Supporting Document for Comments Against Draft 1.3

Hossein Shakiba

Huawei Technologies Canada

January 2025

Figure 178A-7—Sources of noise considered in calculation of COM

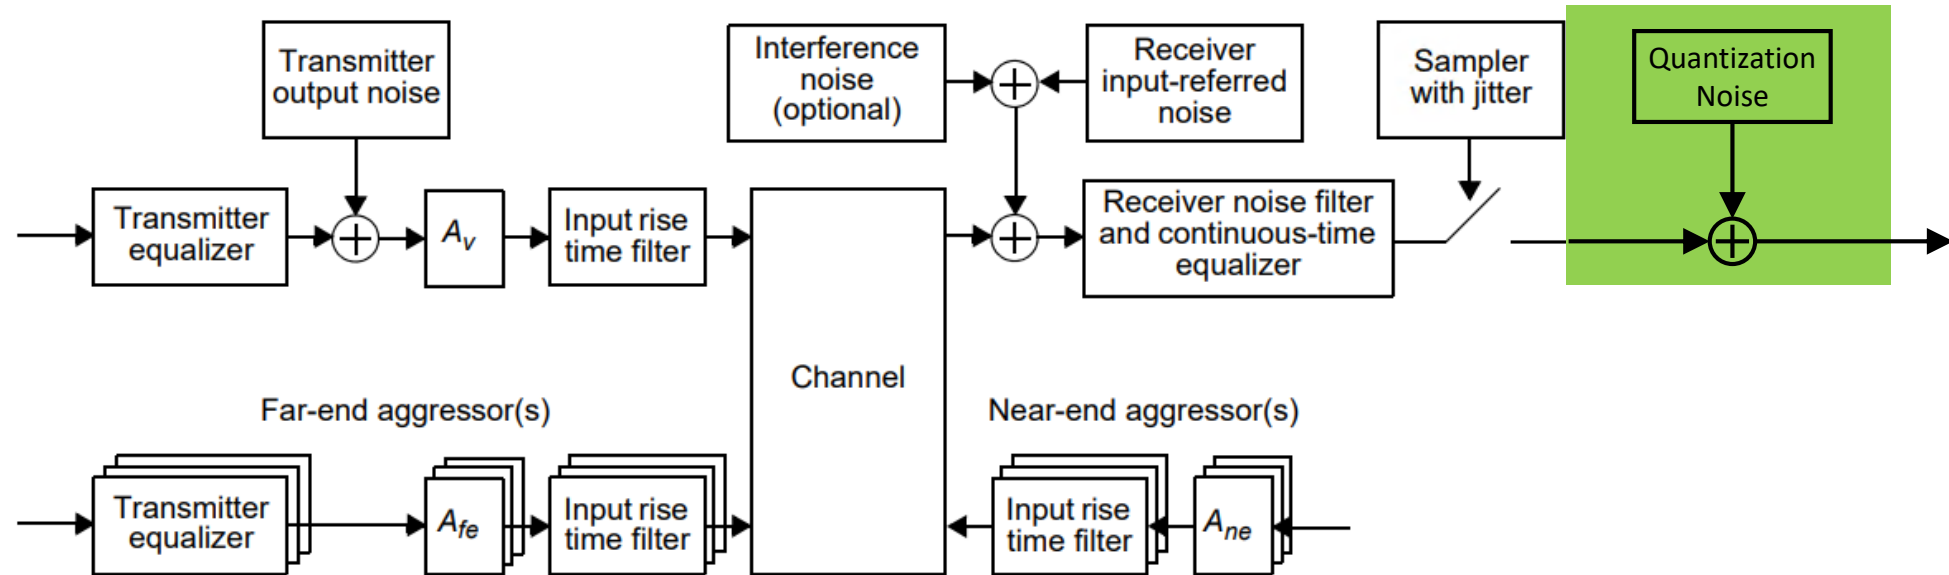
- Comment row #7:
 - ❖ Page 754, Section 178A.1.7, Figure 178A-7
 - ❖ Add quantization noise to the figure

Figure 178A-9—Receiver discrete-time equalizer

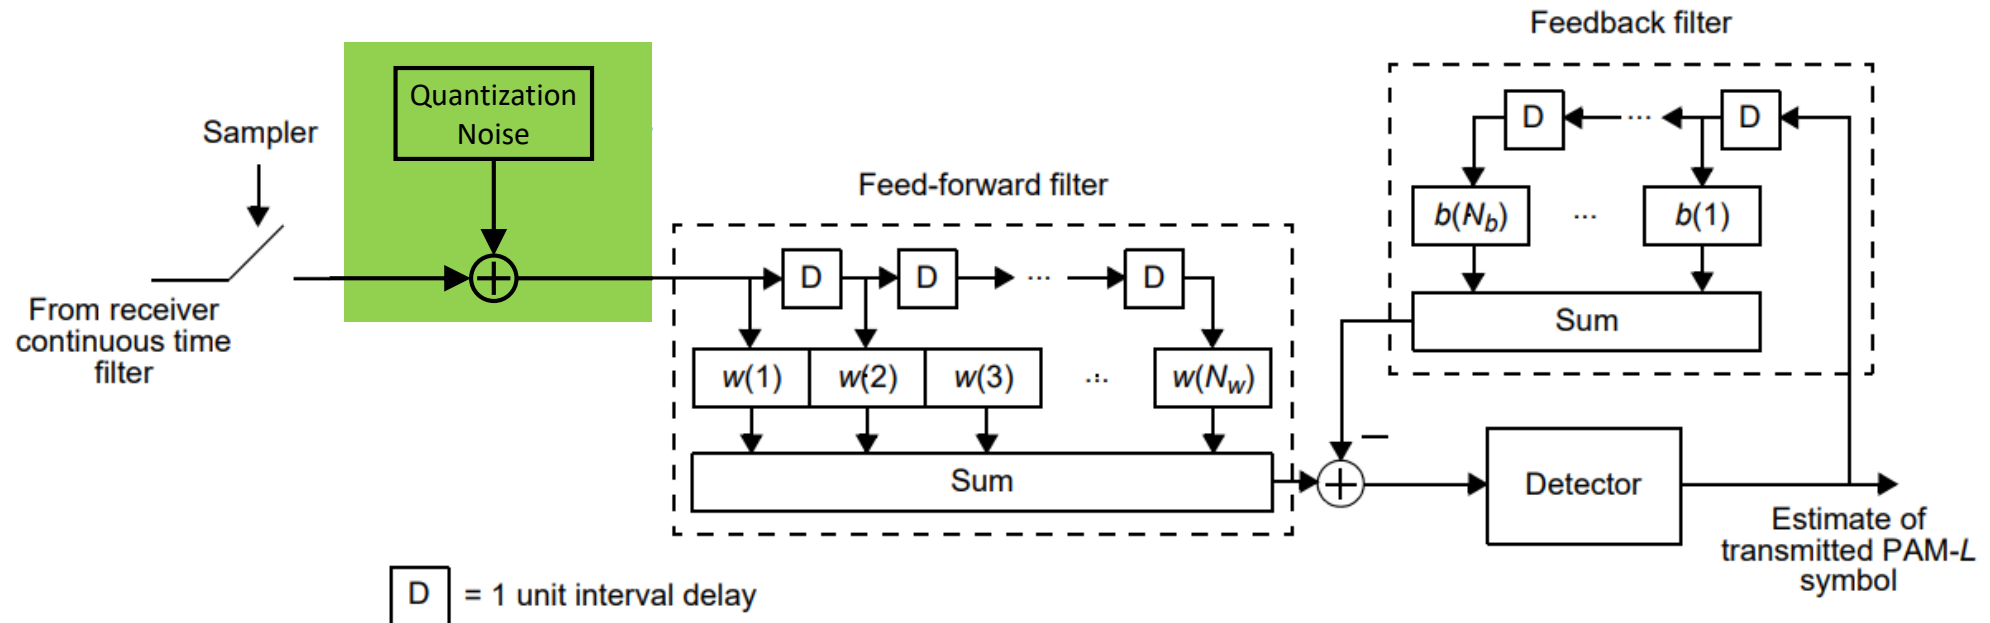
- Comment row #13:
 - ❖ Page 758, Section 178A.1.8.1, Figure 178A-9
 - ❖ Add quantization noise after sampler

Figure 178A-10—Receiver discrete-time equalizer with MLSD

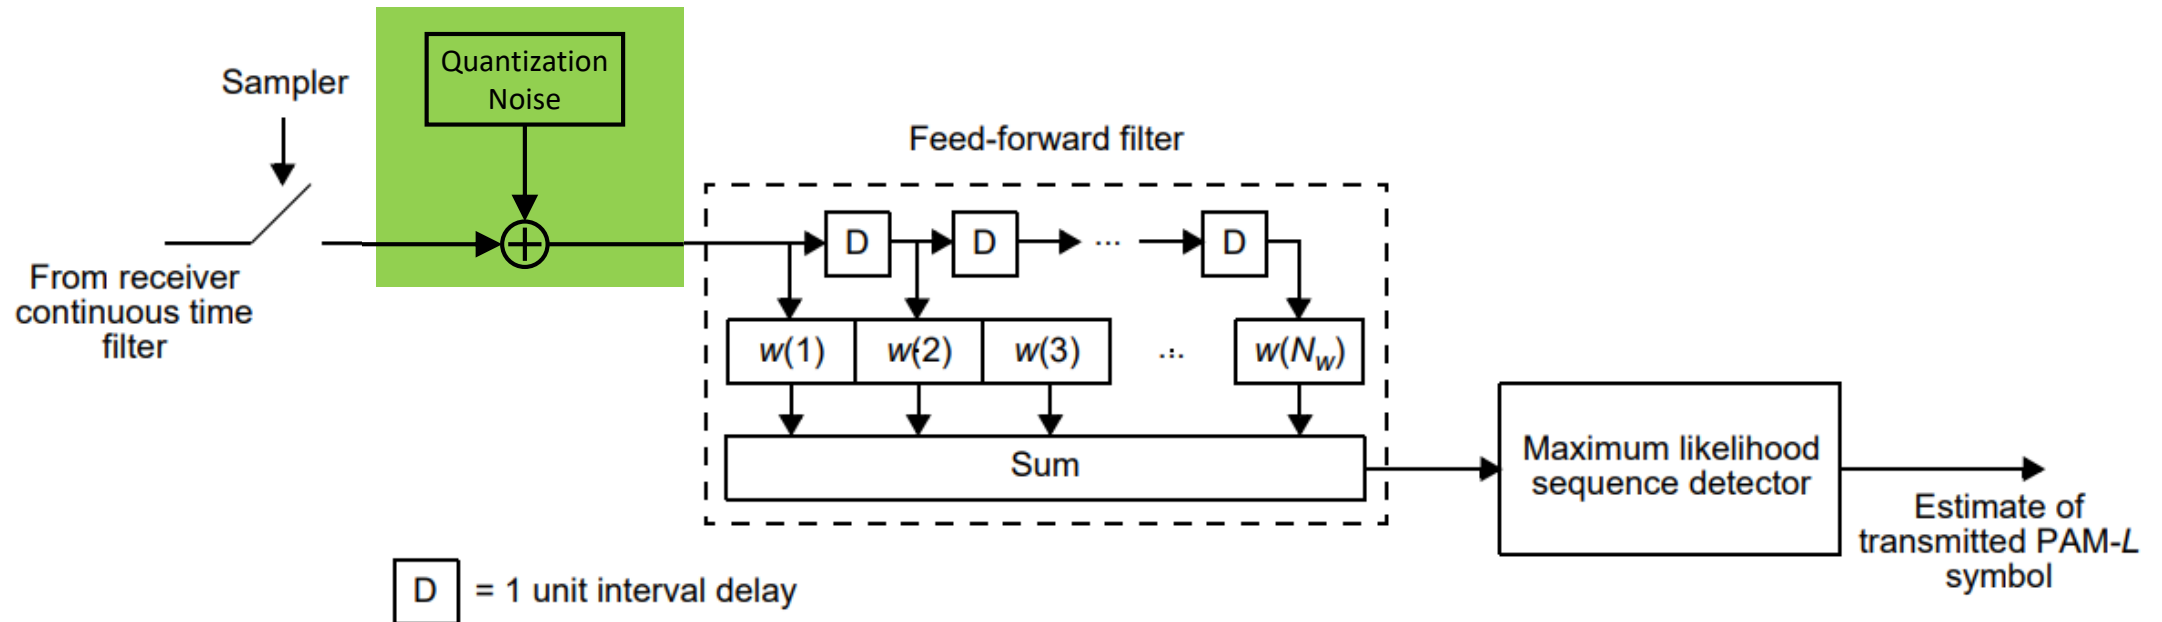
- Comment row #16:
 - ❖ Page 762, Section 178A.1.11, Figure 178A-10
 - ❖ Add quantization noise after sampler
